**STATE OF ALASKA RFP NUMBER 2014-1000-2569
AMENDMENT NUMBER 1**

RFP TITLE: Airborne Geophysical Surveys of Interior and Southern Alaska

AMENDMENT NUMBER 1

Questions and Answers

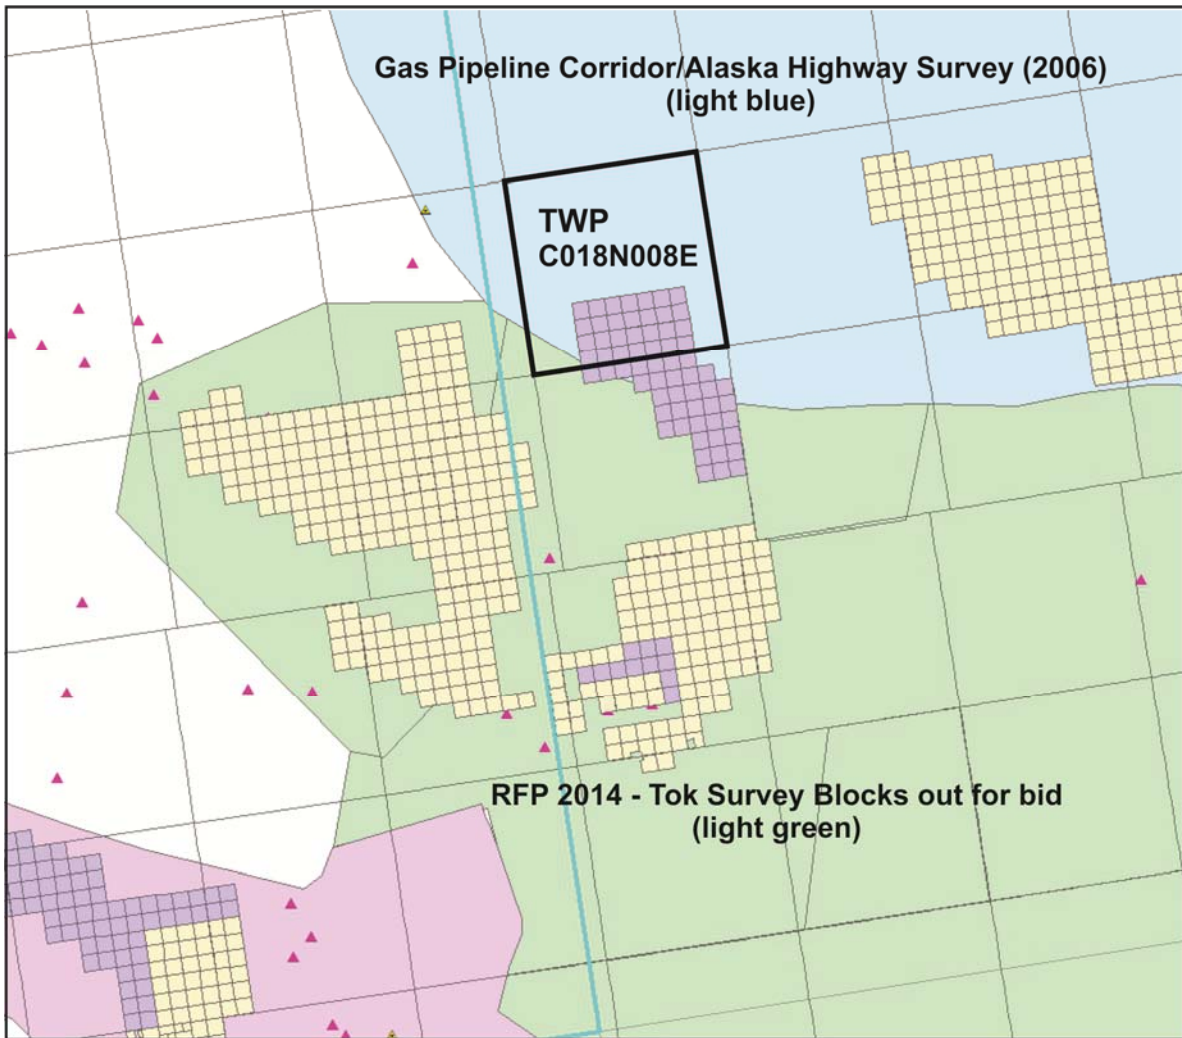
7. Q. I'd like to suggest a minor addition to the survey boundaries. There is a high grade Au epithermal system just barely north of the northwestern most portion of survey Tok_01. Extending the survey to cover sections 25-36 in Township C018N008E would be very useful and I think beneficial to the State of Alaska in the long term. If necessary perhaps the survey could be diminished on the western portion or in one of the areas were development of a mine would be very difficult.

- A. As the enclosed figure shows, Township C018N008E falls within the previously flown 2006 Gas Pipeline Corridor/Alaska Highway DGGs survey, which can be downloaded at the following link: <http://www.dggs.alaska.gov/pubs/project-orderform/83>
